Memo

Date	Thursday, September 16, 2021 (Updated Monday, September 27, 2021)
Project:	Weeki Wachee River Restoration Project
To:	Janie Hagberg Chief Professional Engineer, SWIM Section Natural Systems and Restoration Southwest Florida Water Management District
From:	Joe Wagner, PE, D.NE, BCEE
Subject:	Pipeline and Powerline Corridor Investigation

Figure 3. Rogers Park public boat ramp. (Landside view)

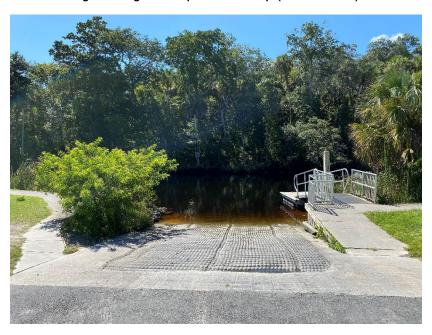
Figure 3. above shows the boat ramp from the landside, which could be the major access point for construction equipment and work crews. Water traffic would be less than the main Weeki Wachee waterway, which could also help minimize the impact on residents and general traffic patterns.

Figure 6. Southwest corner of Shoal Line Boulevard and Ramada Street (looking Northeast)

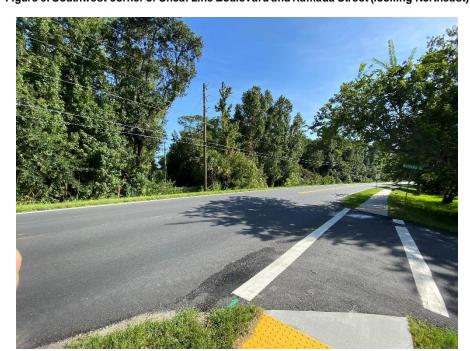
In Figure 6, the current pipeline plan has dredge pipes running from right to left directly towards the power pole. Once again emphasizing the need to negotiate through private property and over/around/under Shoal Line Boulevard. The relocation would avoid impact to Shoal Line Boulevard bridge and a major effort to restore the private property to its current state.

Figure 13. Shoal Line Boulevard, Westside Right-of-Way (looking North)

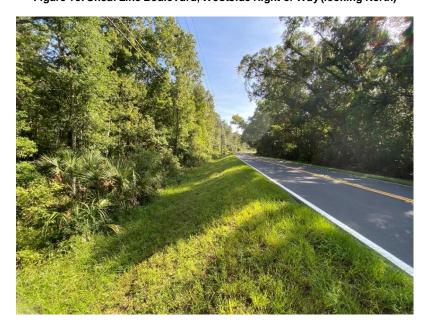
HDR recommends requiring that the Contractor identify and undertake preventative measures to provide a support system, i.e., stakes, to keep the dredge pipe in the right-of-way and out of the vegetation shown in Figure 13. Another example could be a silt curtain system which would serve a dual purpose. It would support the dredge pipe and as containment in case of a burst pipe.
